Special Tool 206-066A –
Does Not Fit Revised Hub Assembly –
Modification Procedure

MODEL 2005 MY-ON
XKR

VIN A41332-ON

ILLUSTRATION 1

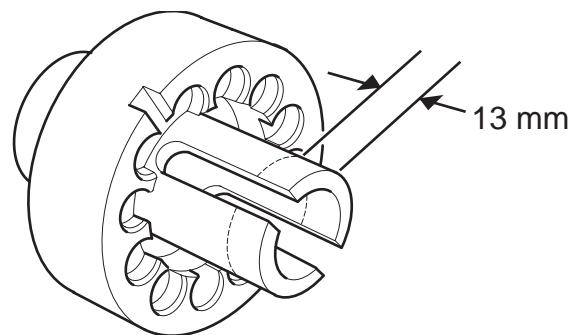
Special tool 206-066A (anti-lock brake system (ABS) rotor nut socket) will no longer fit XK supercharged vehicles from the above VIN, due to running changes to the hub assembly.

A simple modification must be carried out on special tool 206-066A to allow it to fit later production vehicles. This modification will not affect the tool's current usage or warranty.

1. Measure 13 mm (0.51 in.) from the end of the tube and mark a line all the way around the tube (Illustration 1). Place the special tool 206-066A in a vise and use a suitable hacksaw remove the 13 mm (0.51 in.) of material from the tube.

Note: Dress the cut face using a suitable file and remove rough edges.

MATERIAL TO BE REMOVED FROM TOOL 206-066A
